**Subject:** Upper South Creek Advanced Water Recycling Centre (SSI-8609189) Response to Submissions Report

I refer to your email received on 8 April 2022 via the planning portal requesting comments from the Environment and Heritage Group (EHG) in regard to the *Upper South Creek Advanced Water Recycling Centre Submissions Report* dated March 2022 (RtS report).

### Attachment A – EHG comments on Upper South Creek Advanced Water Recycling Centre RtS Report

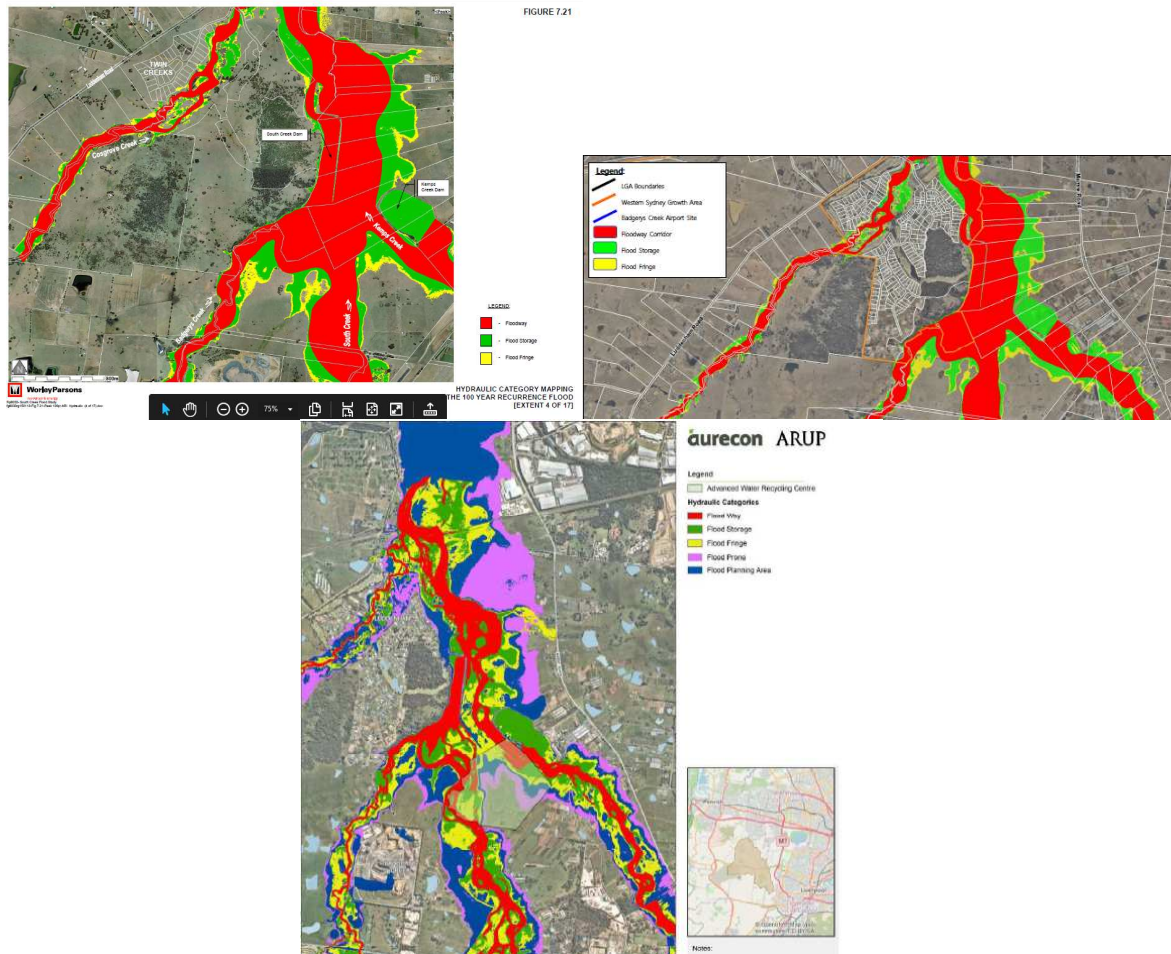
- It appears that the validation undertaken in Section 2.3 utilised 'The XP-RAFTS model' which utilised ARR1987 hydrology and benchmarked against Penrith Flood Study 2015 as outlined in Section 4.3 of the Flood Impact Assessment. EHG highlights again that, this model has not been used in the Aurecon ARUP 2021 hydraulic model. Please refer to EHG's previous comments for further detail.

EHG has previously addressed the inconsistency between the Aurecon ARUP flood assessment 2021 results and Penrith's WorleyParsons (2015) results. In addition, the figures below highlight the inconsistency between Aurecon ARUP flood assessment 2021 results and INSW 2020 results.

The figures above show significant inconsistency in flood behaviour results by Aurecon ARUP flood assessment 2021 (bottom figure) comparing to Council's 2015 results (upper left figure) and INSW flood assessment (upper right figure).
